**BEFORE THE ENVIRONMENT COURT
I MUA I TE KOOTI TAIAO O AOTEAROA**

CONSENT ORDER

(1) the appeals are allowed to the extent that resource consent RM160206 is granted subject to the amended conditions and associated plans entitled "Four Lakes – Stage 3 Residential Development" 29 January 2018, as follows:

The following amendments are to be made to Resource Consent RM160206

**Four Lakes Stage 3
Residential Development
Proposed Staging Plan**

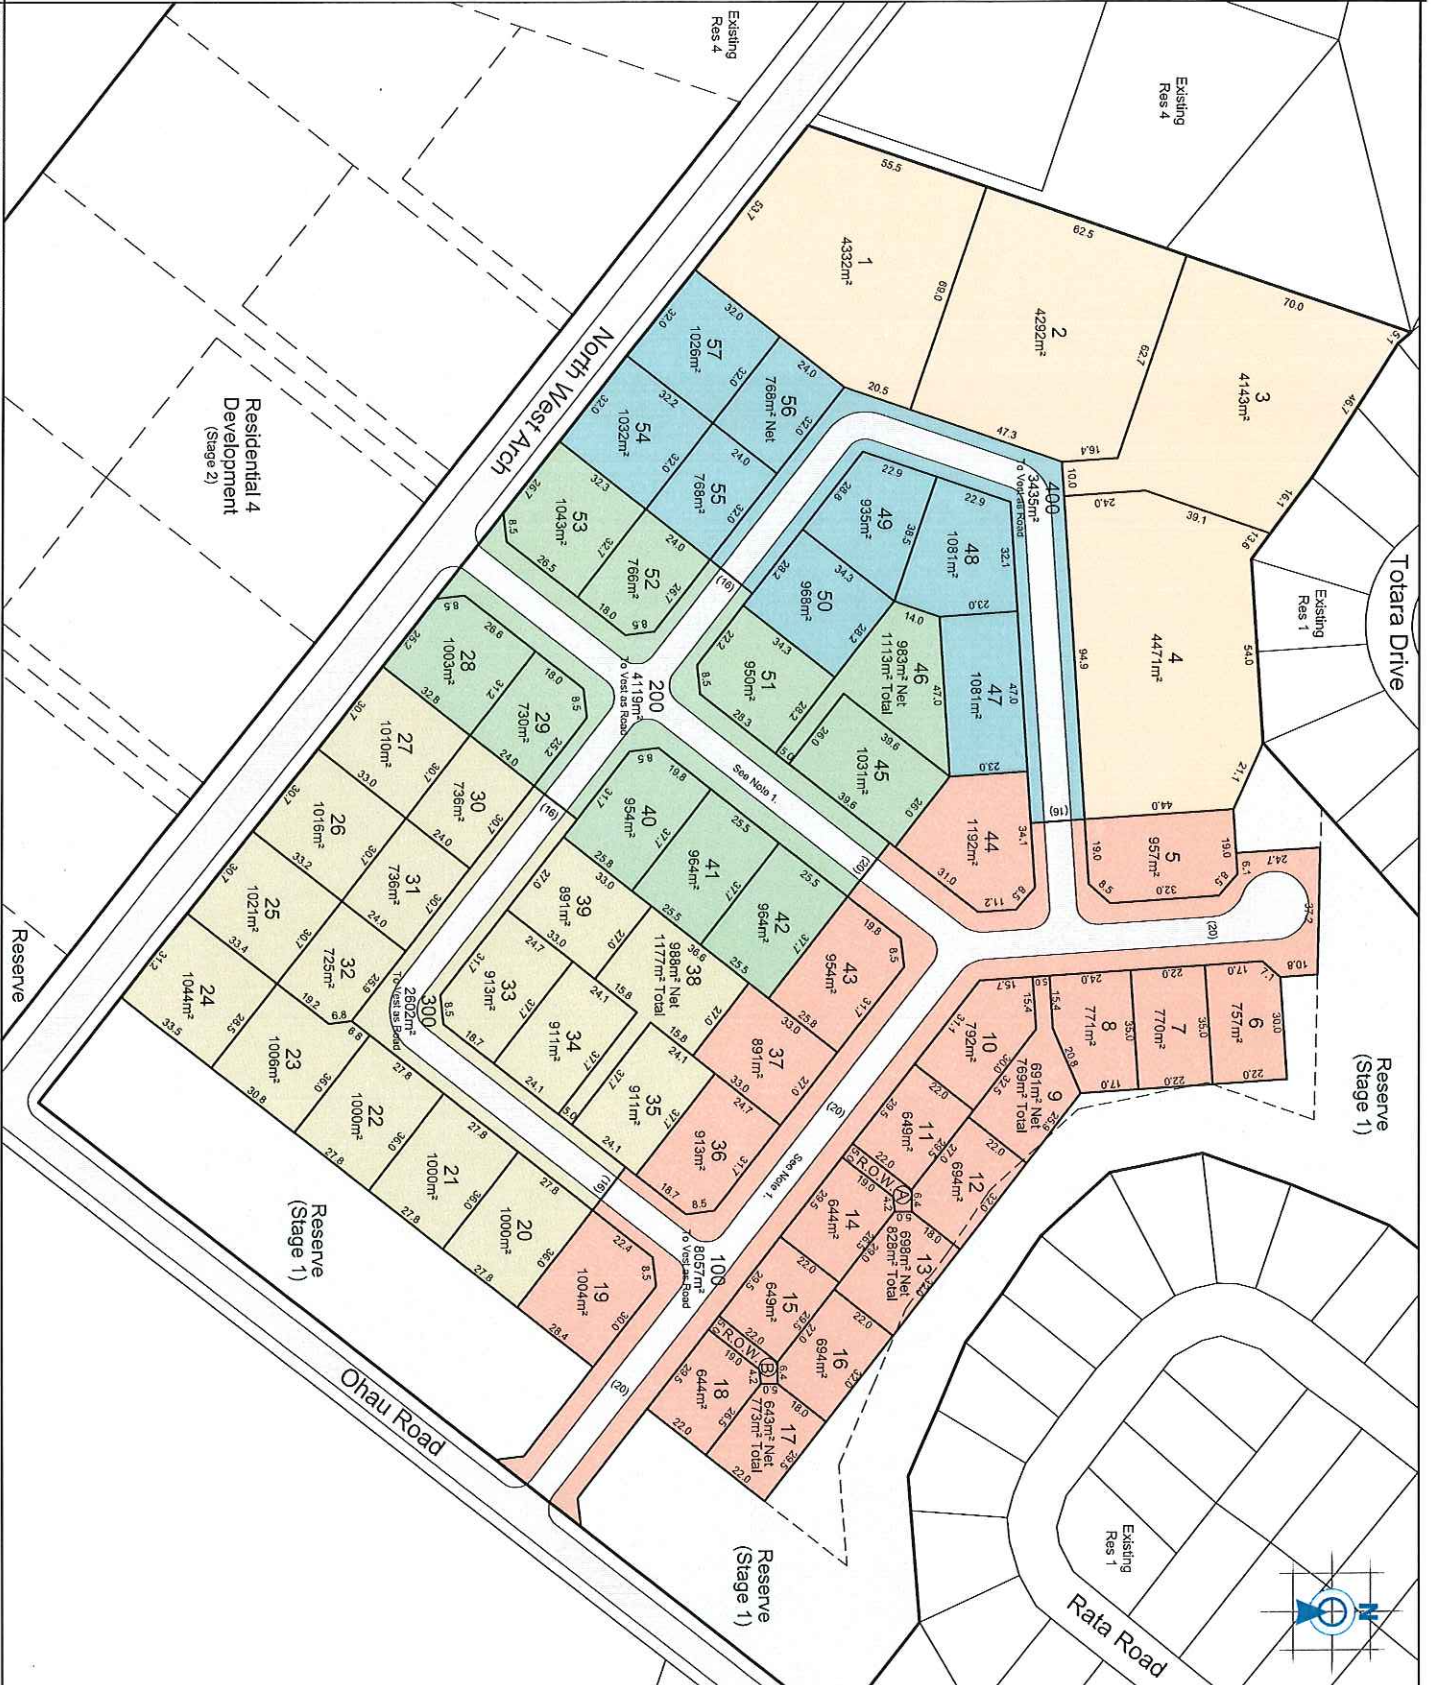
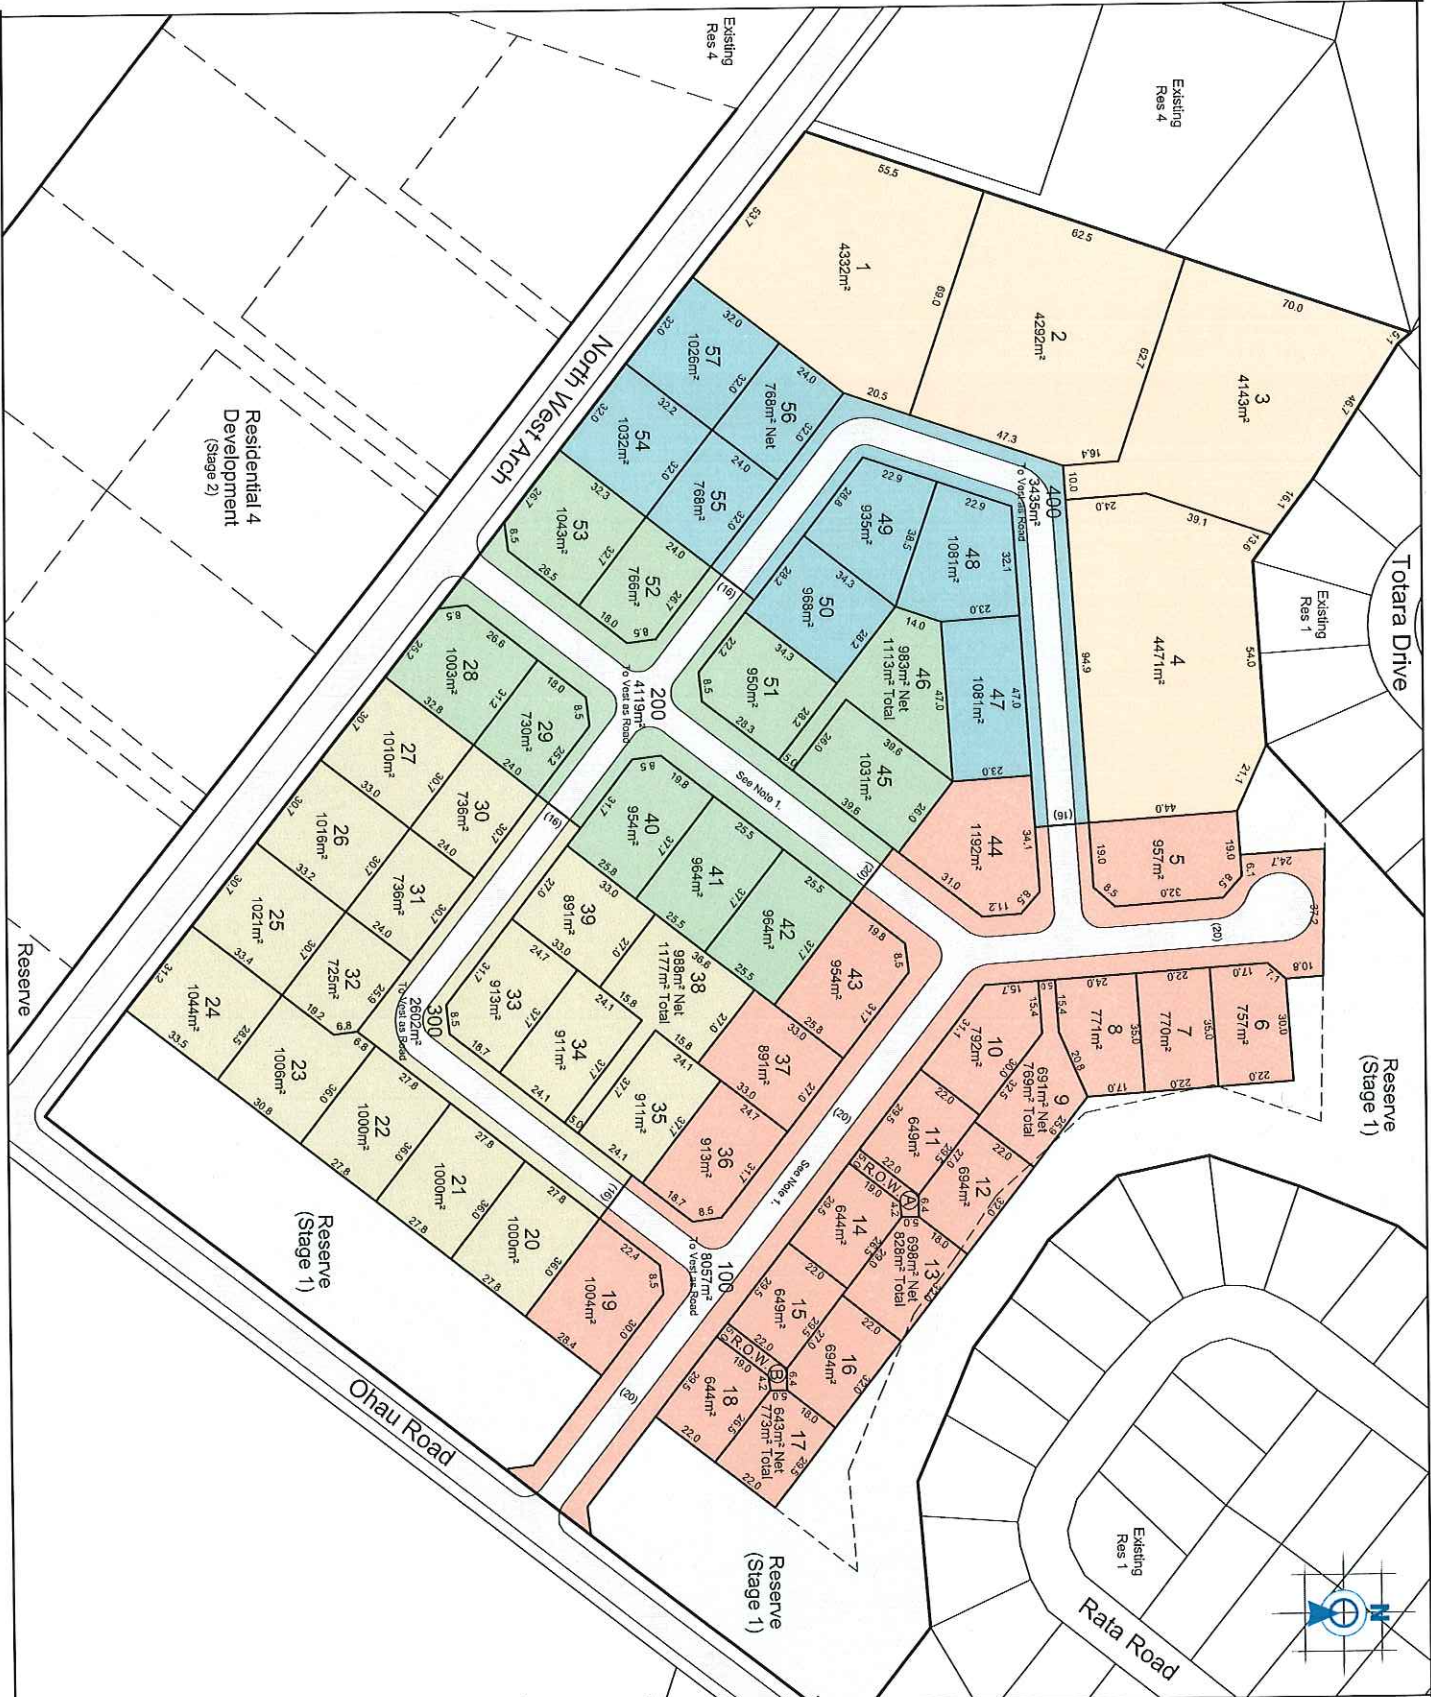
1. All activities authorised by this consent shall be in general accordance with the Paterson Pitts Group Plans "Grant Payne, North West Arch, Four Lakes– Stage 3, Residential Development, Sheets 1,2,3 & 4 dated ~~10/7/2017~~ 29/01/2018, unless inconsistent with any of the conditions below. This subdivision scheme plans is attached as Appendix 'A'
2. Where there is any conflict between the information provided with the application and any condition of consent, the conditions shall prevail.
3. The subdivision shall be undertaken in the following stages as shown on Sheet 1 of 4 –Proposed Staging Plan with a balance lot for each stage other than the last:

Stage 3A – Lots 5-19, ~~38, 39, 48 & 49~~ 36, 37, 43 & 44 (19 lots)

Stage 3B – Lot ~~30, Lots 44 to 47, Lots 50-52, Lot 56-59 & Lots 64-65~~ 28, 29, 40 to 42, 45, 46, and Lots 51-53 (~~14~~ 10 lots)

Stage 3C – Lots 20-~~27-29~~, Lots ~~31-37~~ 30-35 and Lots ~~40-43~~ 38 & 39 (~~21~~ 16 lots)

Stage 3D – Lots ~~53-55~~ 47-50 and Lots 54-57, ~~Lots 60-63 & Lots 66-67~~ (~~9~~ 8 lots)

Stage 3E – Lots 1-4 (4 lots)
